Product change notification (PCN)

Title / short description	Update of approvals for the PLC-INTERFACE product portfolio for use in potentially explosive atmospheres
Affected article category	Relay modules
Change category	Marking, Approval
Change number	CDK250063-00
Reason for PCN/PDN Revision

CDK250063

Update of approvals for the PLC product portfolio for use in potentially explosive atmospheres

old design

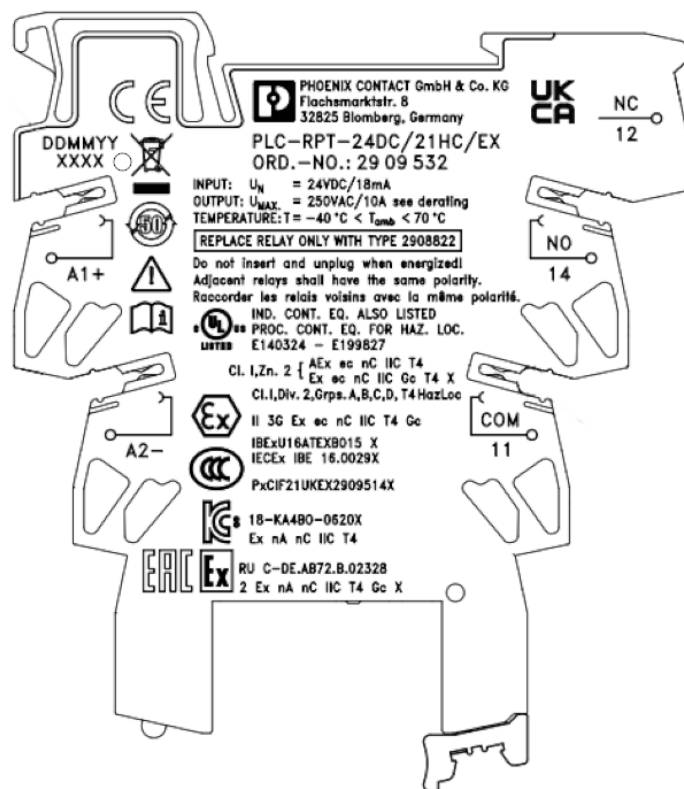
The previous marking text:

"Industrial Control Equipment

ALSO LISTED Process Control Equipment for Hazardous Locations

E140324 E199827"

new design

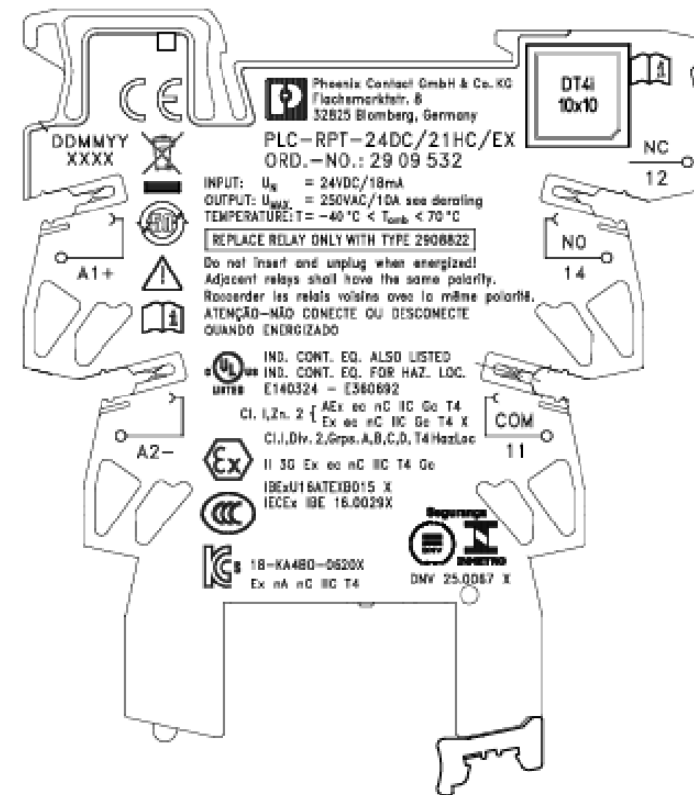
will change to:

"Industrial Control Equipment

ALSO LISTED Industrial Control Equipment for Hazardous Locations

E140324 E360692".

This results in a change of the certificate number (E File). These changes require updates to the product marking, the printed information in the packaging leaflet, and the certificates provided in the e shop. A comparison of the new and current product marking is provided in the attachment.

Additionally, the items will also be updated with the QR Code. The new QR code links directly to the product's Digital Twin, providing centralized and easy access to all relevant documentation, technical data, certificates, and declarations of conformity.
